**Subject: RESPONSE TO REQUEST FOR ADDITIONAL INFORMATION FOR  
THE RIO ALGOM LLC'S APPLICATION FOR GROUND WATER  
ALTERNATE CONCENTRATION LIMITS DATED JANUARY 16,2003**

**Corrective Action Program and Alternate  
Concentration Limits Petition for  
Uppermost Bedrock Units  
Ambrosia Lake Uranium Mill Facility  
Near Grants, New Mexico**

**Application for Alternate Concentration Limits in  
the Alluvial Materials at the  
Quivira Mill Facility  
Ambrosia Lake, New Mexico**

Figure 11. Model for uranium transport in the Alluvium

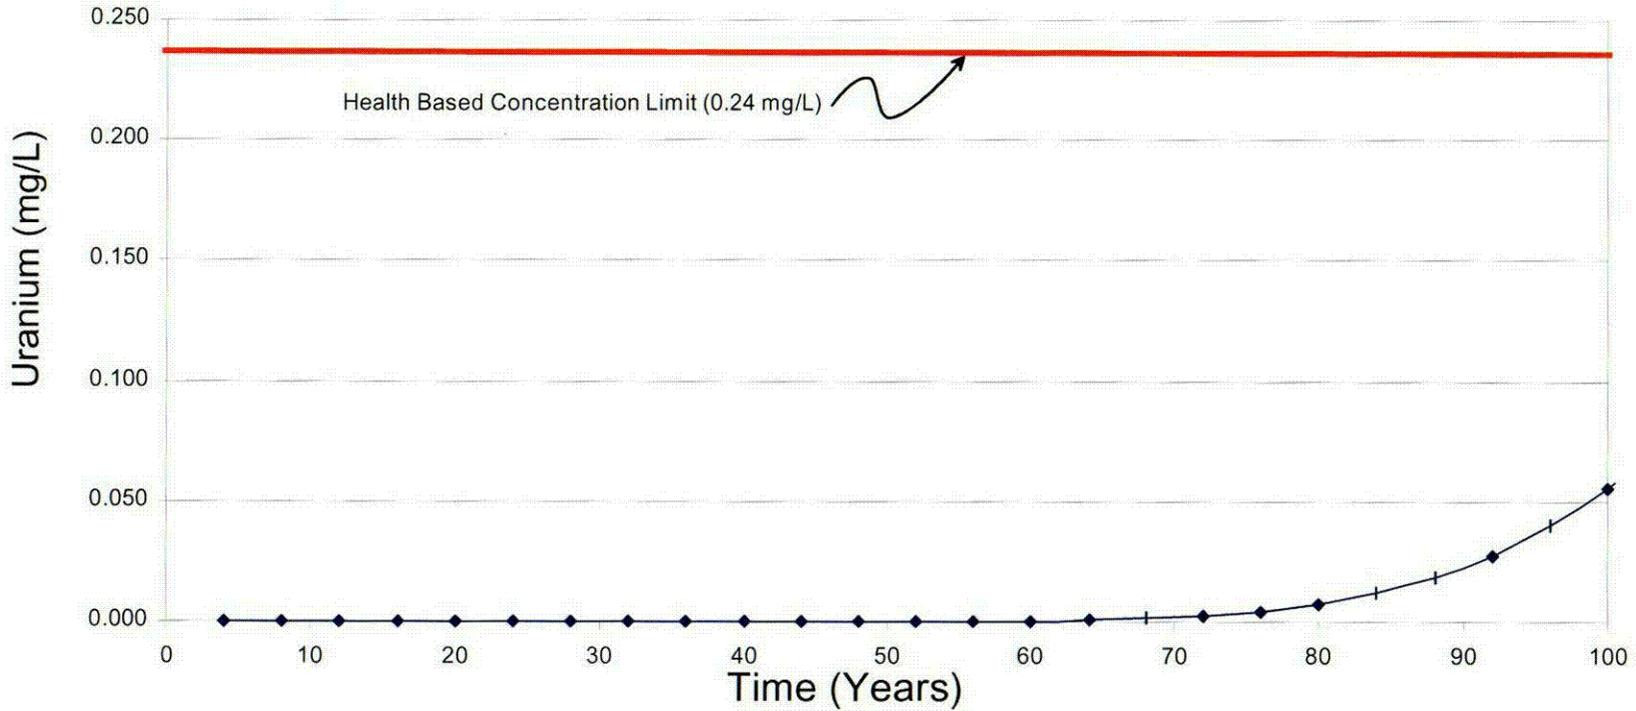
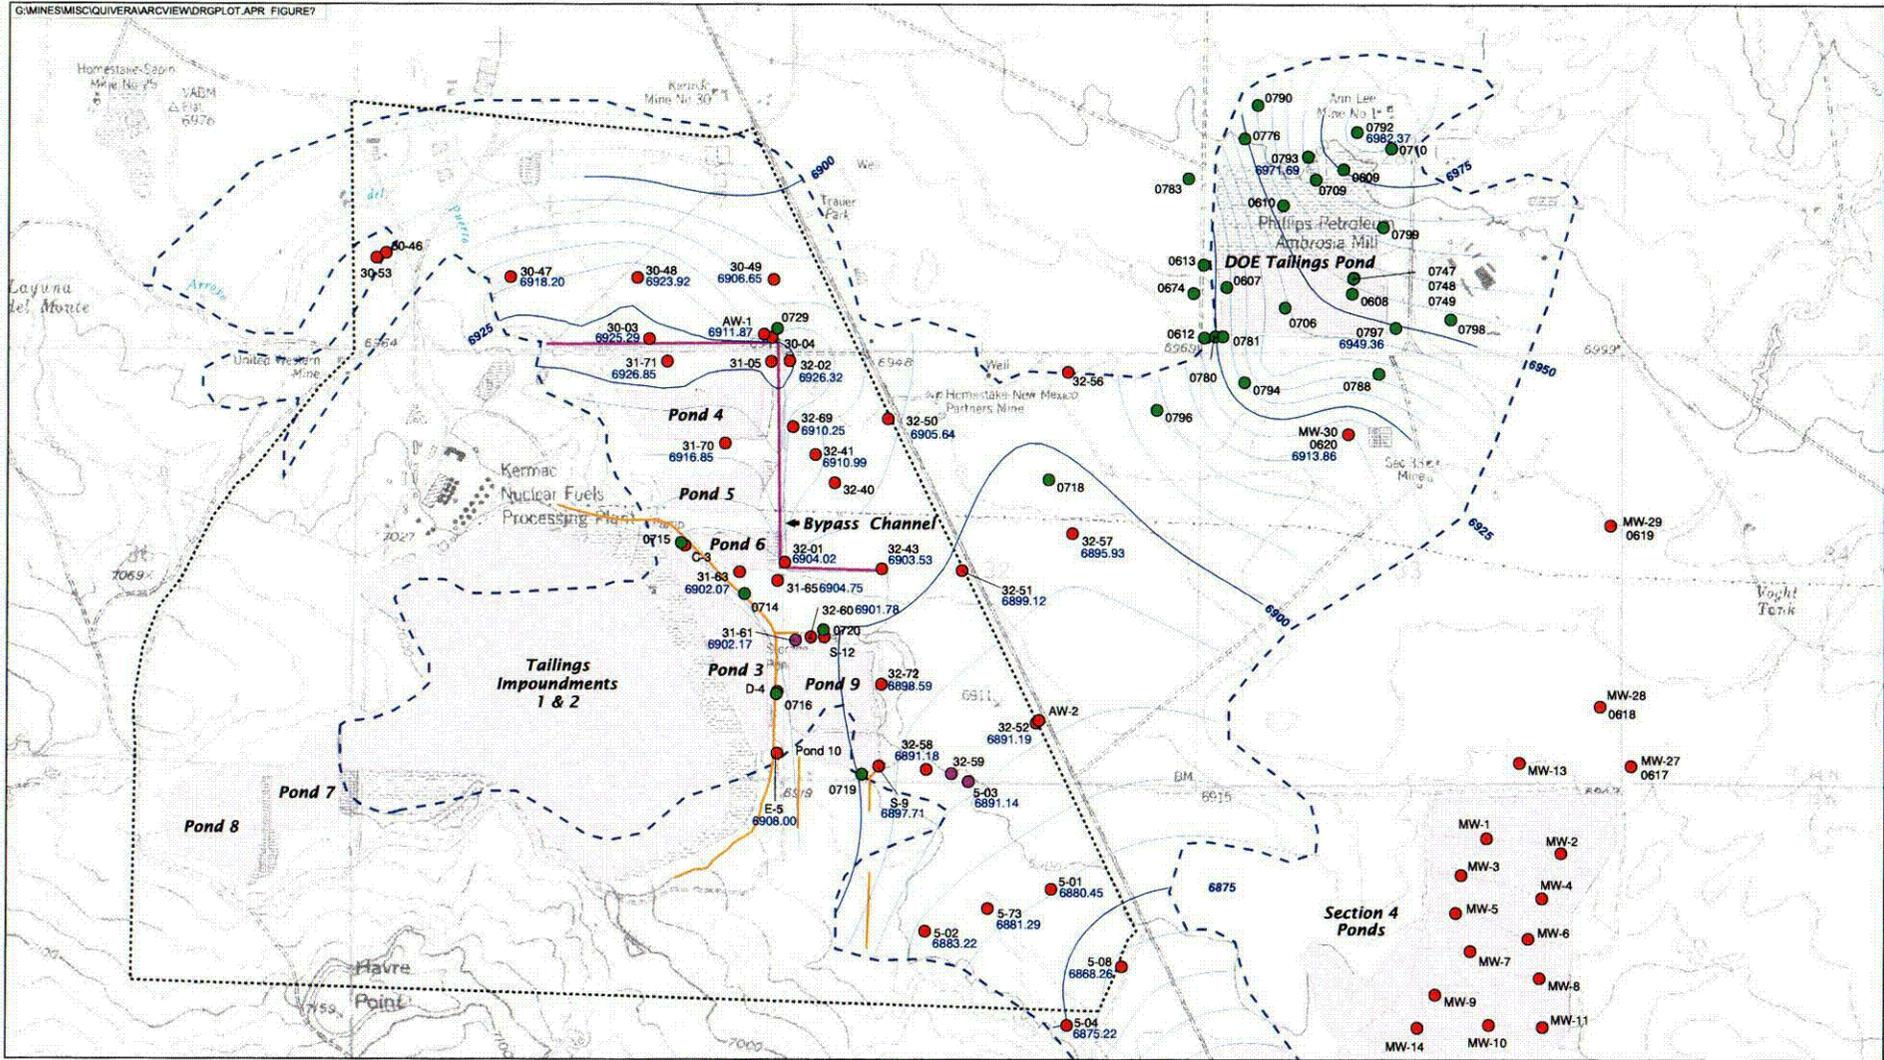
**REQUIRED ACTION:** Provide a more thorough technical basis for the geochemical model, or revise the model. If the model is not better constrained or revised, provide alternative demonstrations of the alluvial attenuation capacity or abandon reliance on attenuation.

Uranium modeling for the Alluvium (Figure 11) shows that the proposed ACL based on the following: a background concentration of 11.1 mg/L, a distance of 5,500 feet from alluvial POC well 31-61 to the POE, and assumptions similar to those used for the Dakota, results in a POE concentration of 0.056 mg/L in 100 years. The 100-year time frame is based on groundwater flow modeling that demonstrates almost complete dewatering of the Alluvium within 100 years. The modeled POE concentration of 0.056 mg/L for uranium results in an attenuation factor of 0.005. The attenuation factor of 0.005 is applied to background levels of constituents of concern as shown in Table 4, along with health-based concentrations.
